EISENHOWER MEMORIAL

U.S. COMMISSION OF FINE ARTS

CONCEPT DESIGN RE-SUBMISSION

SUBMISSION DATE: OCTOBER 02, 2014

OCTOBER 2014 - REVISED DESIGN

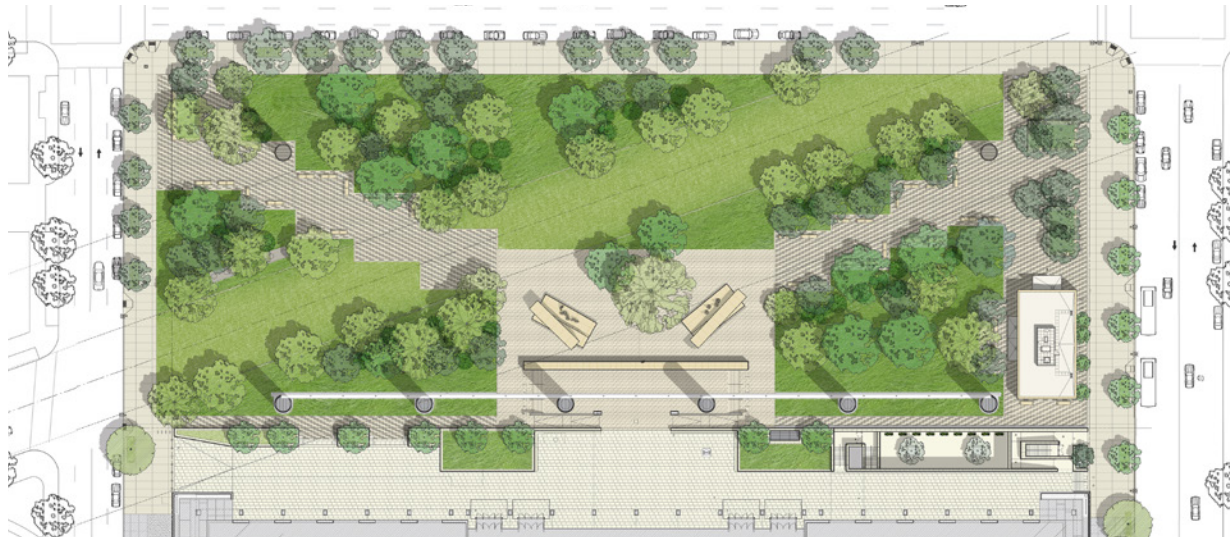
1. The revised design eliminates the East and West tapestries allowing the influence of the adjacent buildings to define and unify the site.
2. Two singular columns replace the East and West tapestries, defining the northern edge of the Memorial site. The proposed northern columns are fully located within the planes of the adjacent building facades.
3. The revised design has widened the view corridor from 95' to 135'. This design revision creates a more proportionally *horizontal* framed view of the U.S. Capitol.

PLAN-DIAGRAM

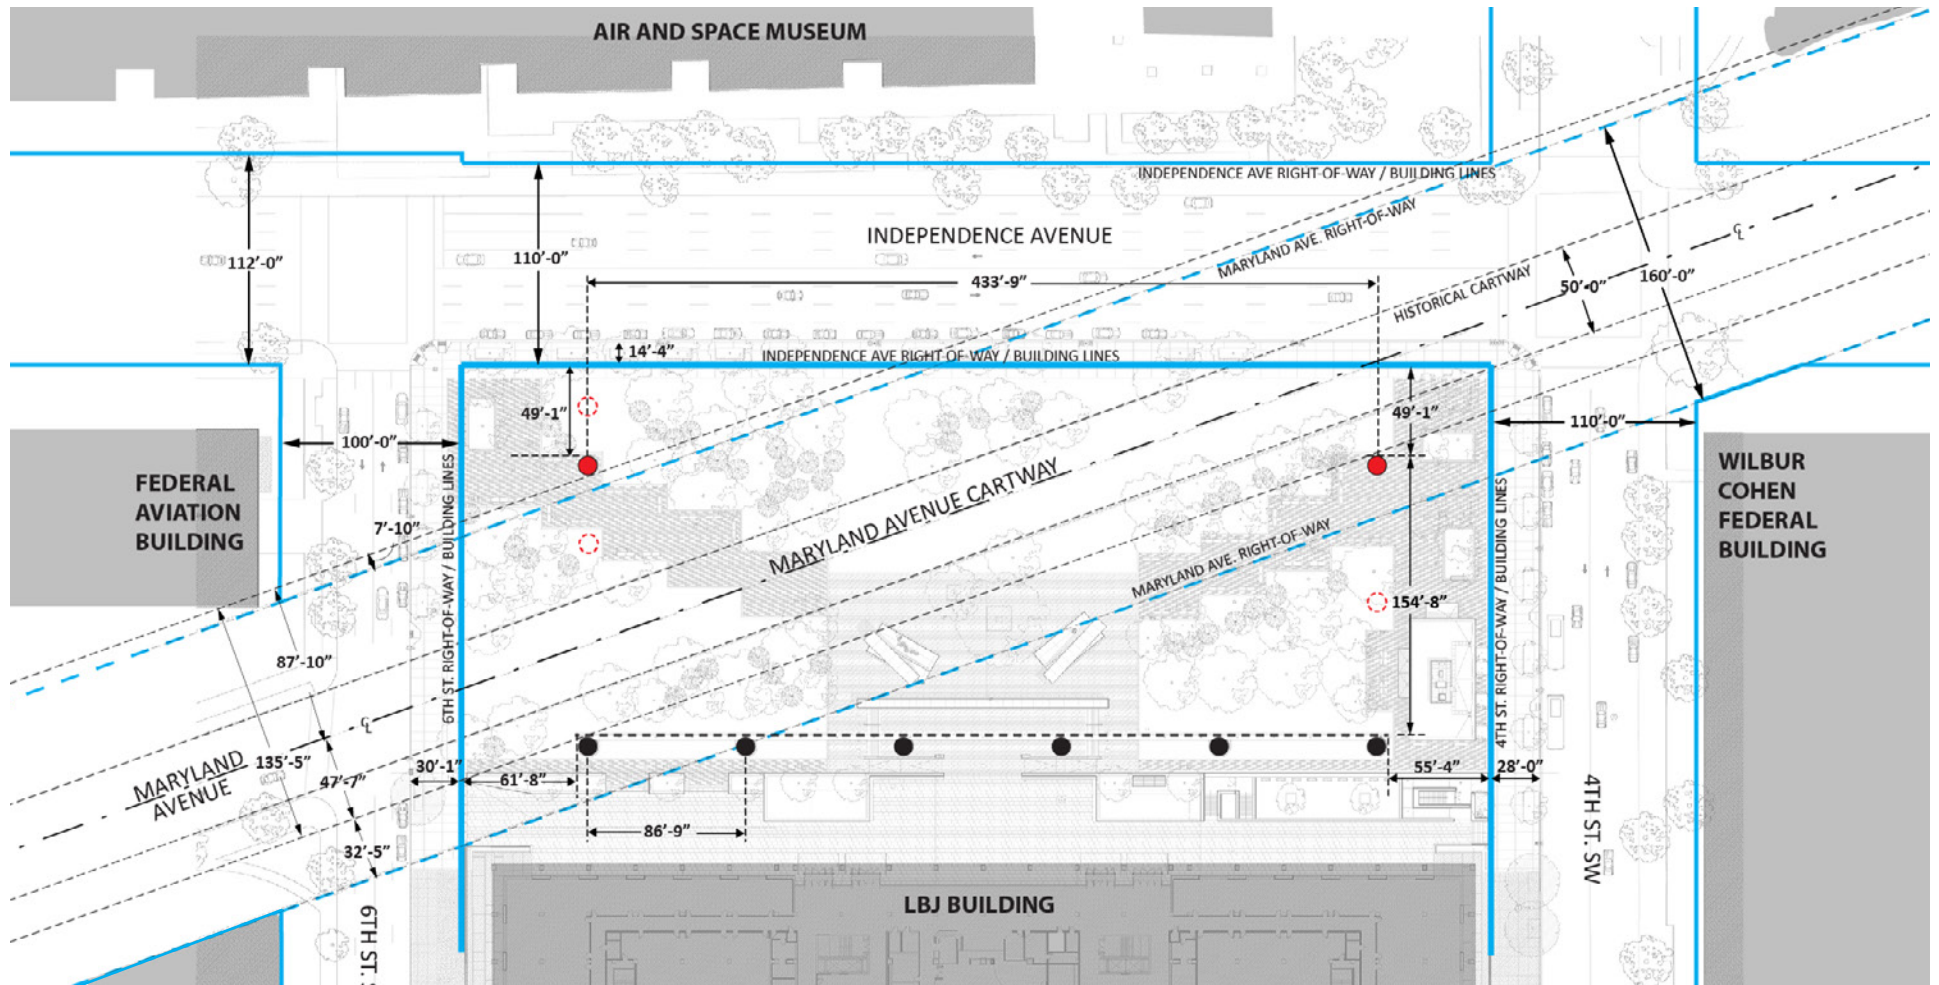
AERIAL VIEW - The design revisions eliminate the East and West tapestries, allowing the influence of the adjacent buildings to help define and unify the site.

- The design revisions eliminate the East and West tapestries, allowing the influence of the adjacent buildings to define and unify the site.
- The northern singular columns are located fully within the planes of the adjacent building facades.
- The design revisions widen the Maryland Avenue viewshed from 95' to 135' wide creating a proportionally *horizontal* framed view towards the Capitol building.
- The April 2014 concept included three columns that were within the 160' ROW. The revised plan includes only two columns within the southern edge of 160' ROW.

MARYLAND AVENUE VIEWSHED TOWARDS CAPITOL

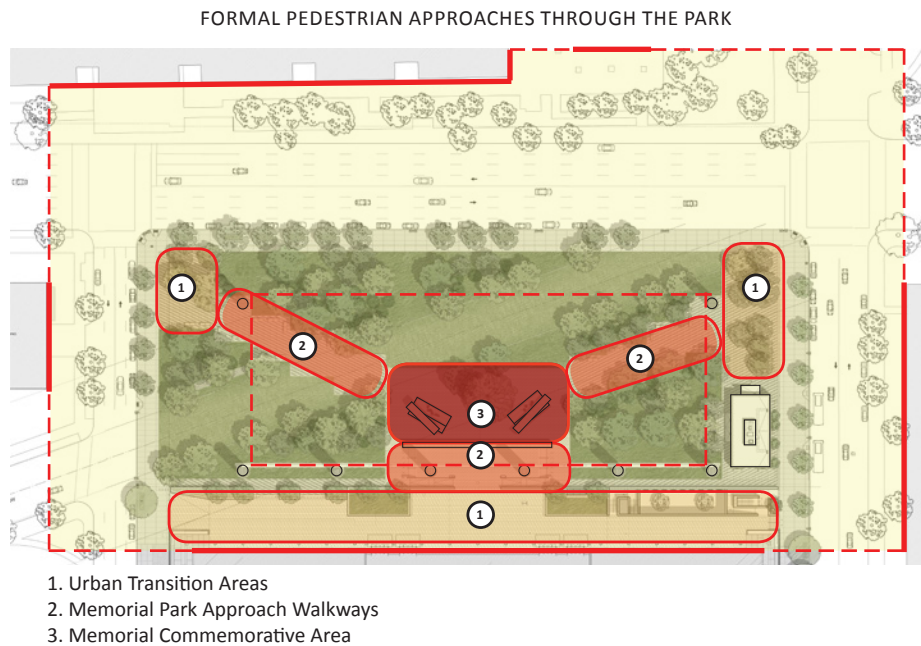
VIEW ALONG MARYLAND AVENUE TOWARDS CAPITOL - The design revisions widen the Maryland Avenue viewshed from 95' to 135' wide, creating a proportionally *horizontal* framed view to the Capitol building.
